Comment Summary – 2nd Submission - Zoning By-law Amendment Application – WDD Main St. Inc.

February 9, 2024
Our File: 122006-002

Re: Zoning By-law Amendment – 2nd Submission
11 Main Street, Morriston
Township of Puslinch

Drawn	M.I.M.	Design	M.I.M.	Project No.	2366-6537
Check	B.W.	Check	B.W.	Scale	1:500
				Dwg.	FIG. 4

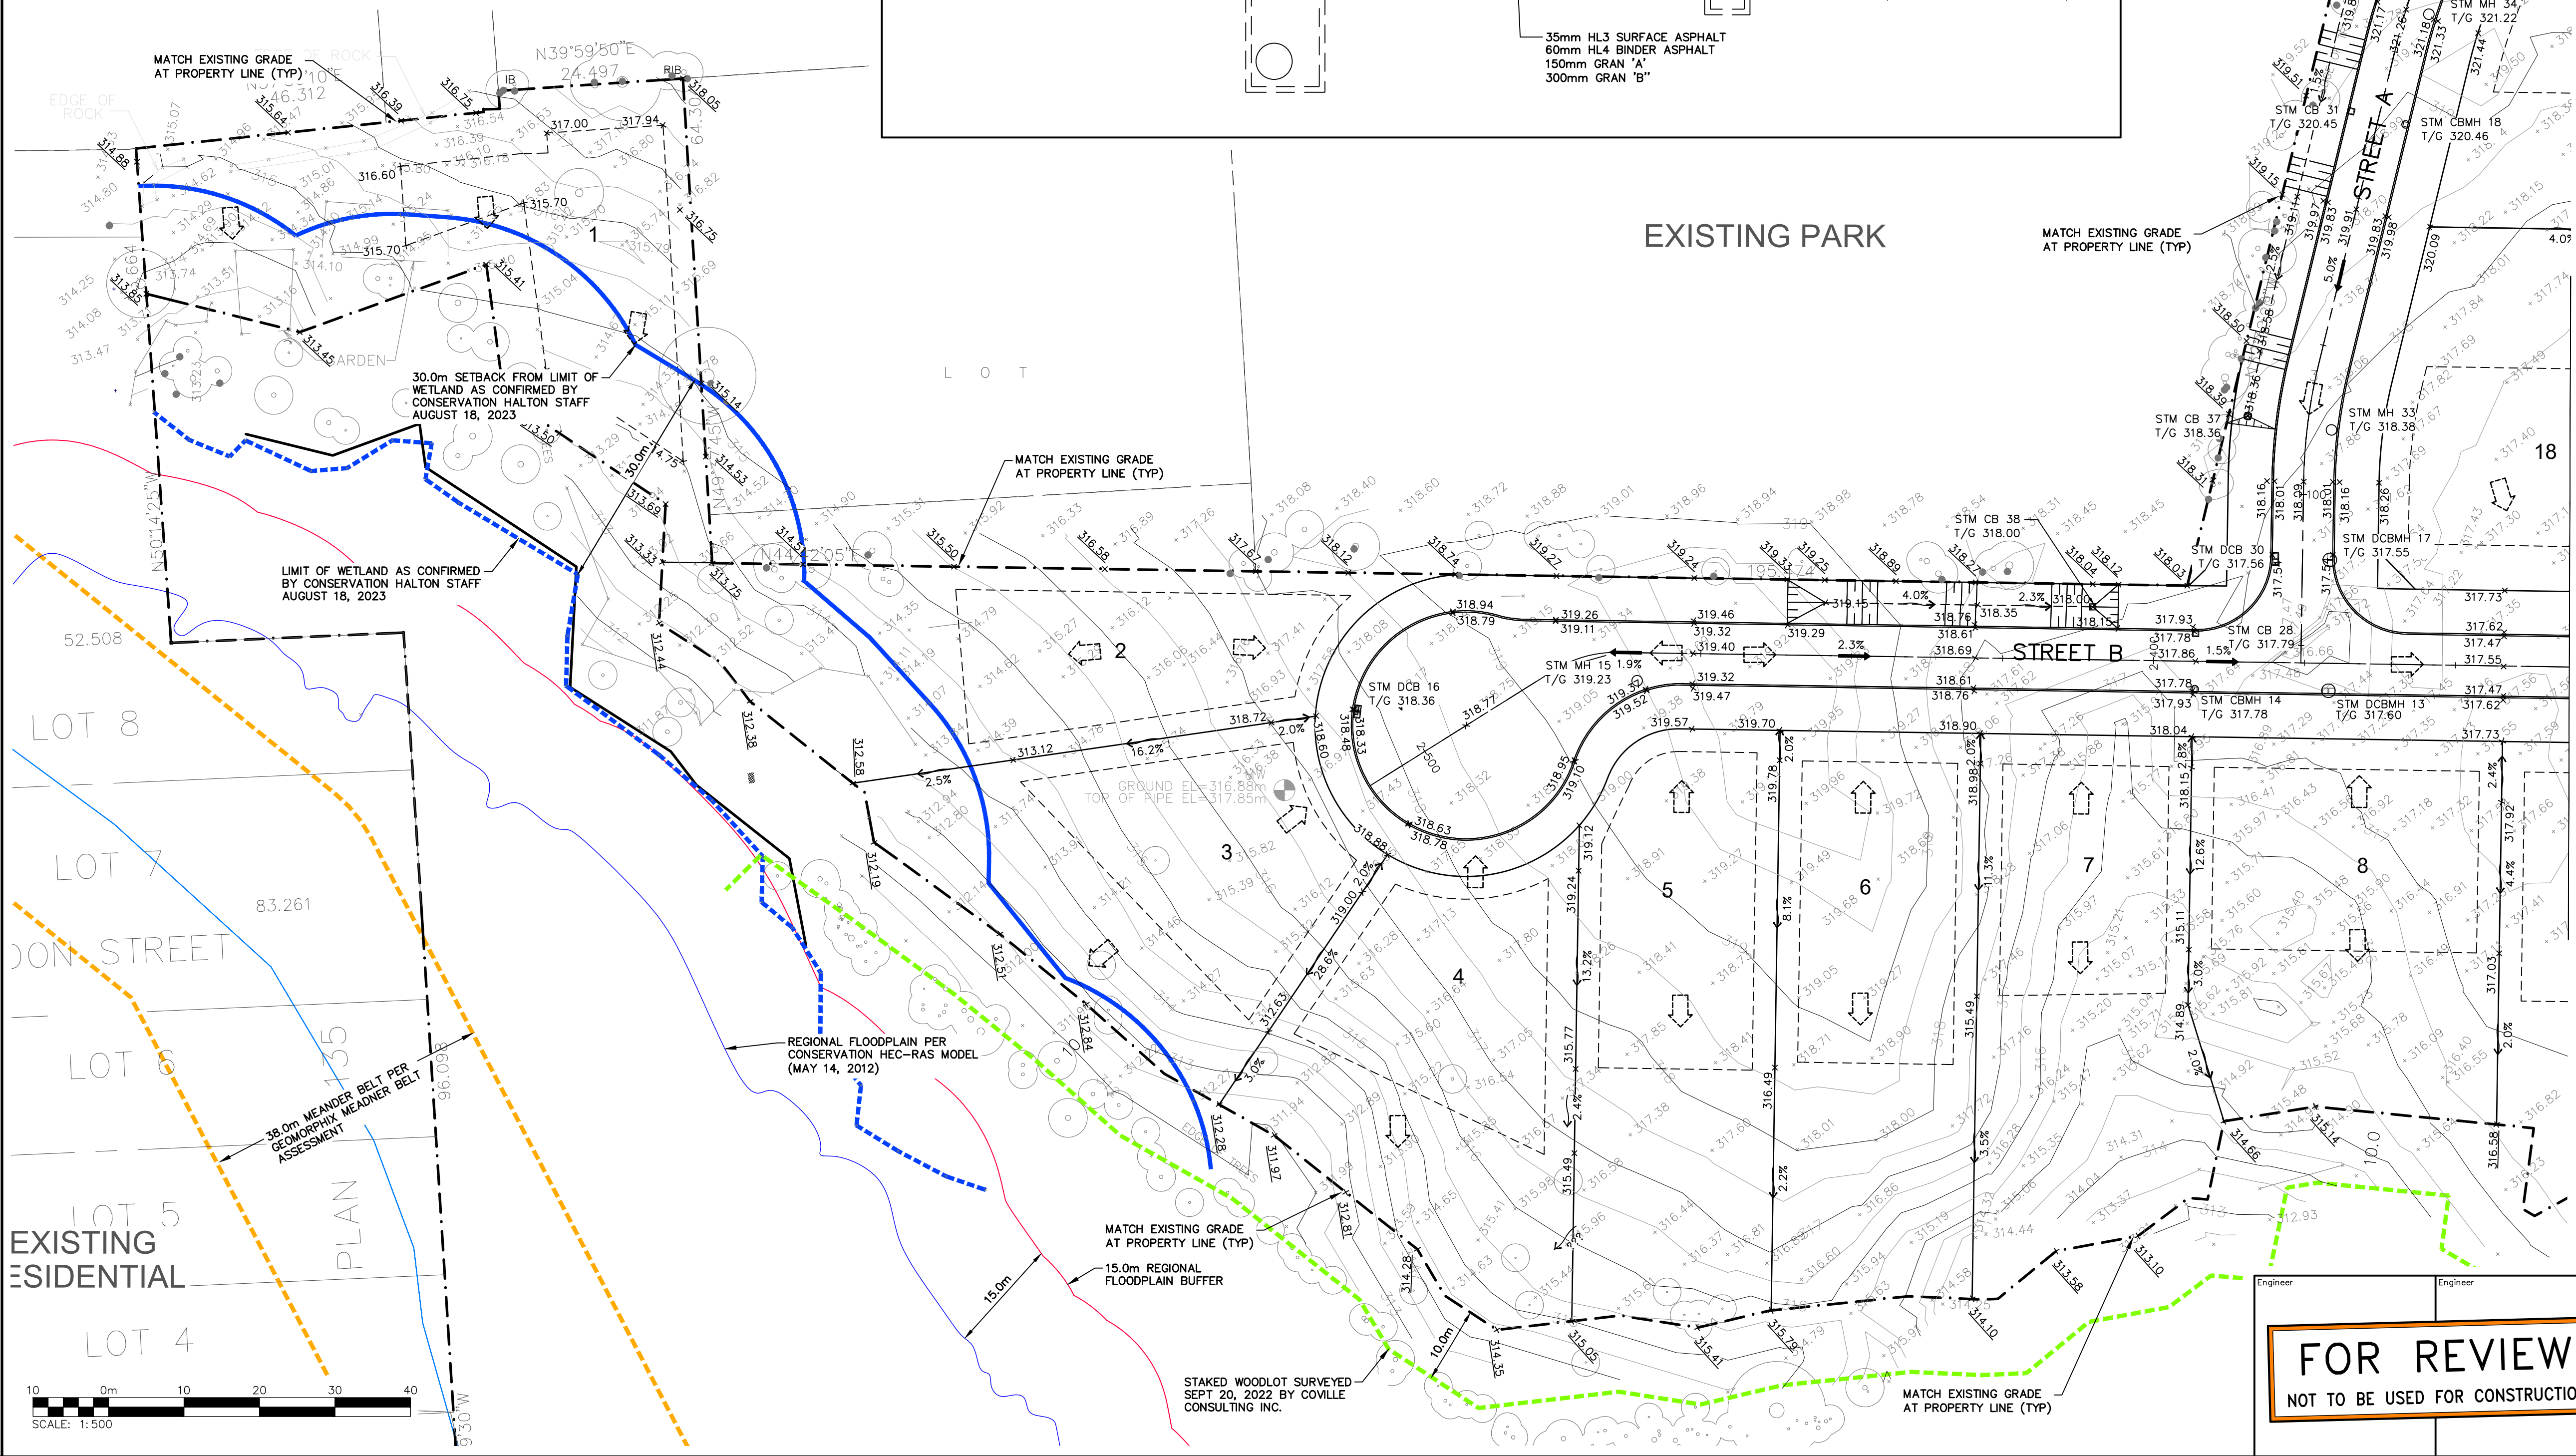
Item No.	Matter / Requirement	Document Reference	Date Issue Identified	Comment
				<p><u>GMBP Comment (February 9, 2024)</u> Based on the grades shown in the Site Grading Plan at the property line along external catchment EX1, stormwater ponding at the corner of this external catchment will flow onto the site and enter the proposed storm sewer network. Additionally, Ochs Street in external catchment EX2 appears to be draining towards the existing Badenoch Street right-of-way rather than the proposed site. Please review and account for in stormwater management calculations.</p> <p>For clarity, add overland flow arrows to both external catchments in the drainage area plans (Figures 6 and 7).</p>

17.	Ponding at Catchbasin	Engineering Plans	February 9, 2024	<p><u>GMBP Comment (February 9, 2024)</u> The Site Grading Plan shows that proposed catchbasin CB 36 has a T/G elevation of 316.89, which is 1.5m lower than the adjacent curb elevation proposed. Considering the proximity of CB 36 to the property line, there is concern that stormwater will pond onto the neighbouring property at catchment EX2.</p> <p>Please show that the storm sewer leaving CB 36 will have the capacity to convey the flow generated by EX2 with ponding contained to the subject property up to and including the 100yr storm event. Additional topographic survey may be required on the adjacent lands.</p>

Drawn	M.I.M.	Design	M.I.M.	Project No.	2366-6537	
Check	B.W.	Check	B.W.	Scale	1:500	
					Dwg.	FIG. 5

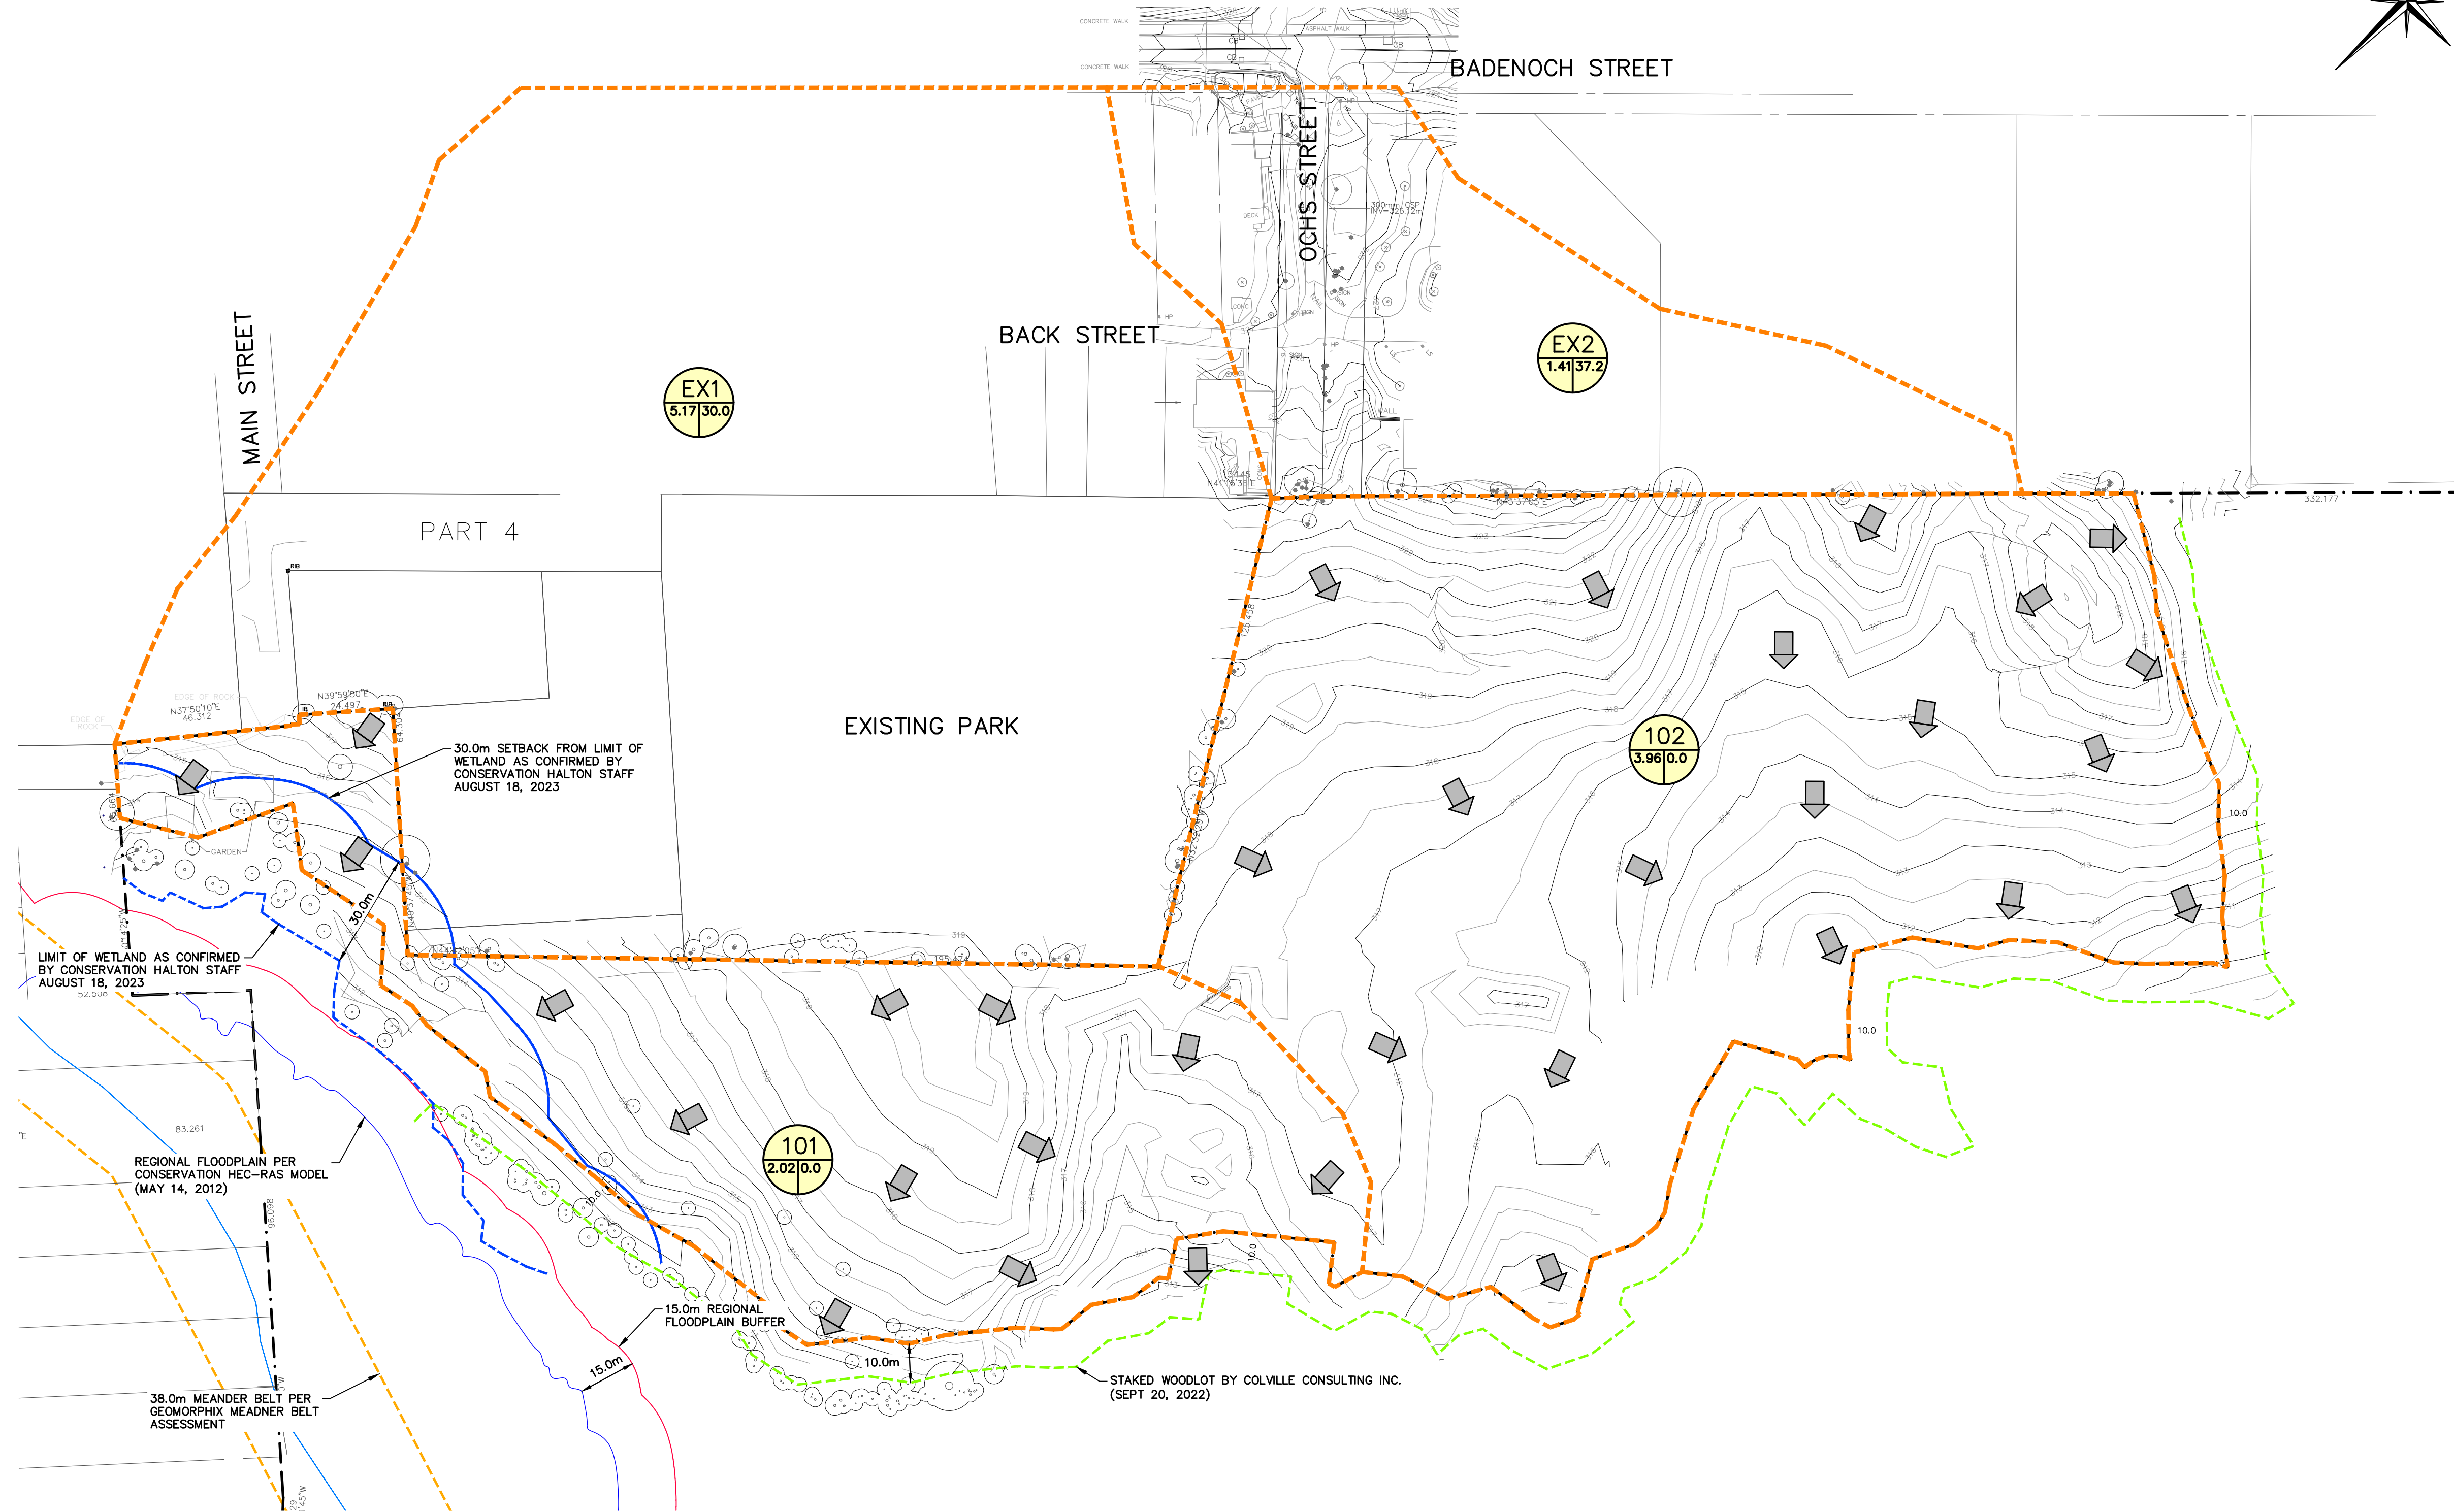
Item No.	Matter / Requirement	Document Reference	Date Issue Identified	Comment
19.	Ochs Street Cross-Section	Engineering Plans	February 9, 2024	<u>GMBP Comment (February 9, 2024)</u> Please provide cross-sections for the proposed Ochs Street right-of-way, including proposed retaining walls and swales due to their close proximity to existing buildings.

Figure 15 Recommended Retaining Wall Relocation

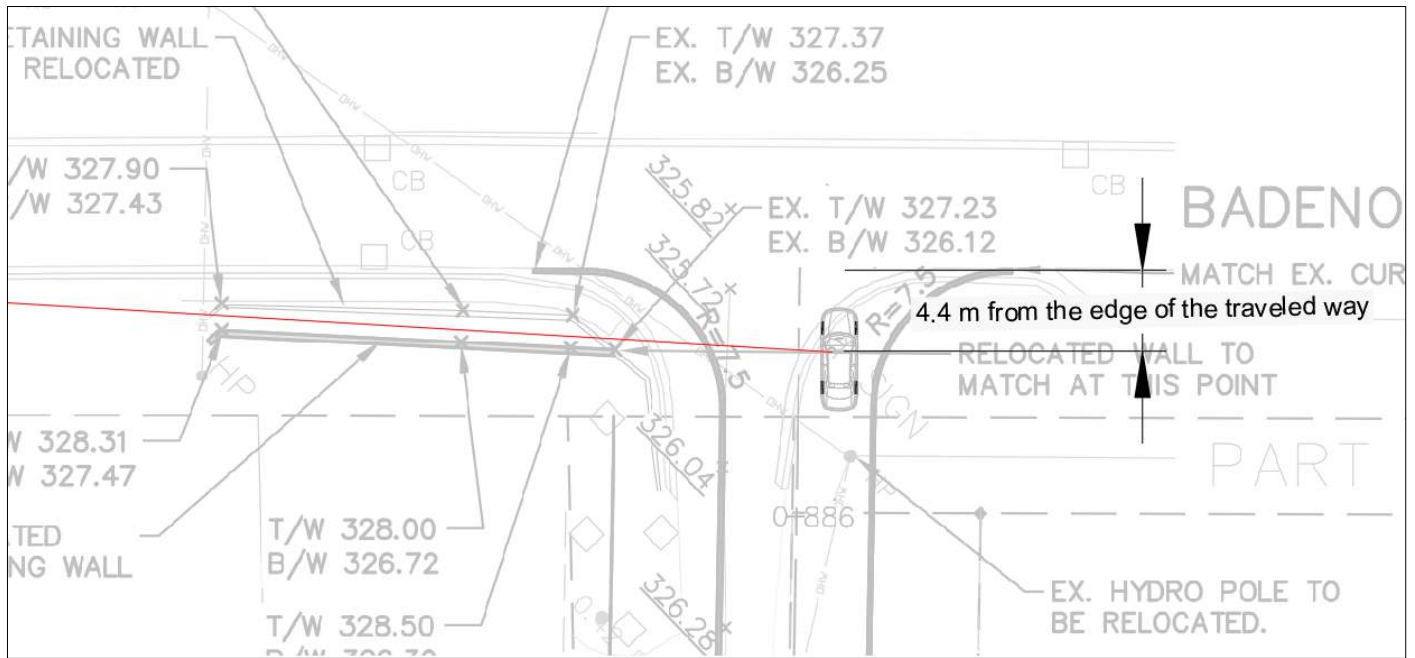
24.	Sight Distance Figure	Traffic Impact Study	February 9, 2024	<u>GMBP Comment (February 9, 2024)</u> In Section 9 of the Traffic Impact Study (TIS), please include an additional figure that is similar to Figure 15 but enlarged to illustrate the extent of the sight distances described in Table 9.

Figure 16 Modified Rural Cross-Section

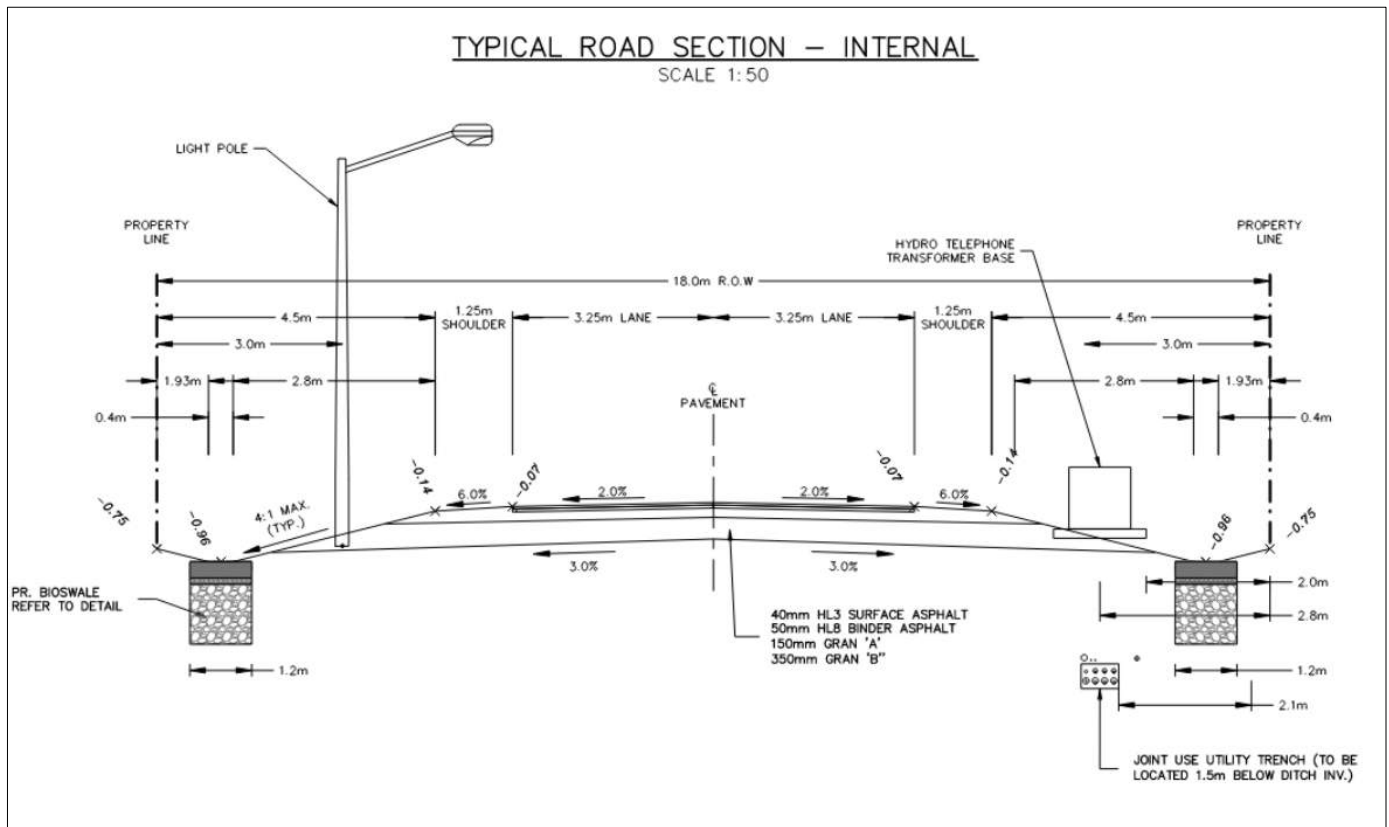
25.	Internal Road Geometry Figure	Traffic Impact Study	February 9, 2024	<u>GMBP Comment (February 9, 2024)</u> Section 10 of the TIS needs to be revised using the Township of Puslinch 20m wide urban road cross-section. Additionally, the TIS states that the proposed right-of-way is 18m wide. Please revise to 20m to be consistent with the engineering reports and drawings.
